SI B 24 52 01  
Automatic Transmission

**Voluntary Recall Campaign # 01V-196: E53 Transmission Selector Position Switch Replacement**

E53 X5 4.4iA with M62TU produced 9/99 – 2/01

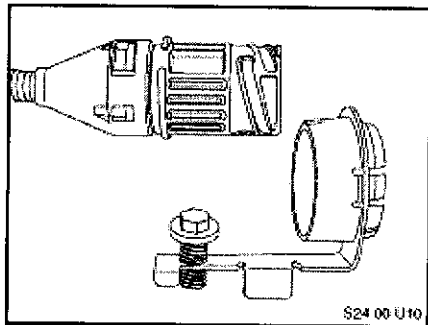
1. Locate the selector switch on the passenger side of the transmission.
2. Remove the two bolts on the selector switch heat shield. Remove the heat shield.
3. Check the color of the selector switch plastic case:

<b>Selector Switch color</b>	<b>Repair</b>
Tan (yellow/brown) color	<b>Replace the selector switch</b> as outlined below.
Black	Selector switch is OK. <b>Do not replace</b> the switch.

4. **If the selector switch case color is tan**, then remove the two bolts on the switch and slide the switch off the selector shaft.
5. Unplug the selector switch connector.
6. Unclip the selector switch harness from the clips. Do not remove the clips from the transmission.

7. Transfer the locking collar / bracket (as one piece) to the new switch connector.

8. Install the new switch onto the selector shaft. Reinstall the two bolts and torque to 10 Nm.
9. Connect the selector switch plug and then route the harness into the clips.
10. Reinstall the heat shield.
11. Check the operation of the selector switch: turn on the ignition, move the trans. shifter lever through all gear positions and "sport". Ensure the gear indicator in the instrument cluster corresponds with the shifter position.
12. Clear all faults in the EGS/DME.
